**CITY PLANNING COMMISSION**  
 1231 "I" STREET, SUITE 200, SACRAMENTO, CA 95814

**APPLICATION:**

**LOCATION:** 8401 Jackson Road

# EXHIBIT C FLOOR PLANS

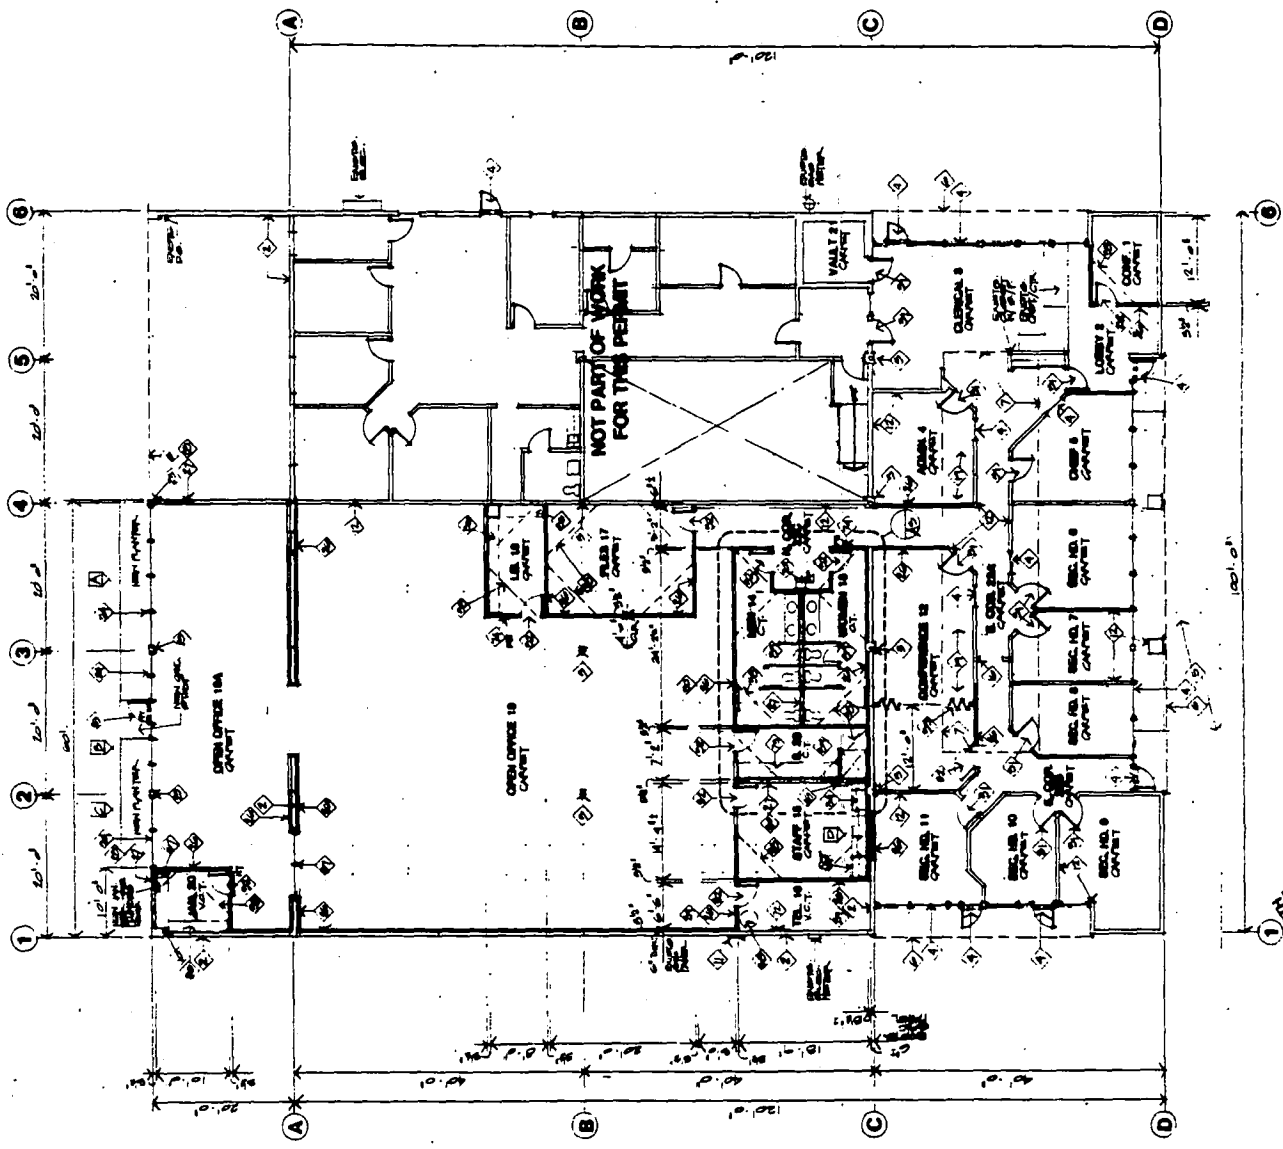
All required improvements on the site are existing. The applicant proposes to modify the existing site plan by adding a 60' X 20' addition to the rear of Building C. The addition will place Building C 10 feet from Building D (Exhibit A). No door openings are proposed on the west elevation of the proposed addition. The addition will not encroach into any setback or parking areas. All other modifications to this site will be interior tenant improvements.

The submitted site plan does not indicate the location of a trash enclosure. Trash dumpsters located outside the buildings will be required to meet the Zoning Ordinance requirements for trash enclosures.

The submitted plans indicate 104 parking spaces. The proposed use requires 101 parking spaces. Adequate parking is provided on site to accommodate the office and warehouse development of the entire site. The plans do not indicate any bicycle parking. Staff recommends that seven bicycle parking spaces (1:15 parking spaces) be added to the site due to the shift from warehouse to office use. The site is within 400+ feet of the College Greens Light Rail Station. Access to the light rail station is not provided from the site. The people using the light rail station will be required to around the adjacent site to the light rail station located on Folsom Boulevard. Staff recommends vanpools to the light rail station. Implementation of a Transportation Management Plan (TMP) will be required prior to issuance of building permits. Trip reduction measures such as transit passes, carpool/vanpool and showers and lockers on the site may be required. Processing time for approval of a TMP may take up to 60 days. Therefore it is advisable that the applicant obtain the necessary TSM processing application in advance of the building permit.

- 1. A Transportation Management Plan (TSM) shall be submitted for the review and approval of the City's TSM Coordinator prior to issuance of building permits.
- 2. A minimum of seven bicycle parking spaces shall be provided subject to the requirements of the Zoning Ordinance.
- 3. Trash dumpsters located outside the buildings shall meet the Zoning Ordinance requirements for trash enclosures.
- 4. The office use for which this special permit is granted shall be established within two years from date of approval. If the office is not so established the special permit shall expire. A special permit time extension for one year may be requested, in writing, 30 days prior to expiration.
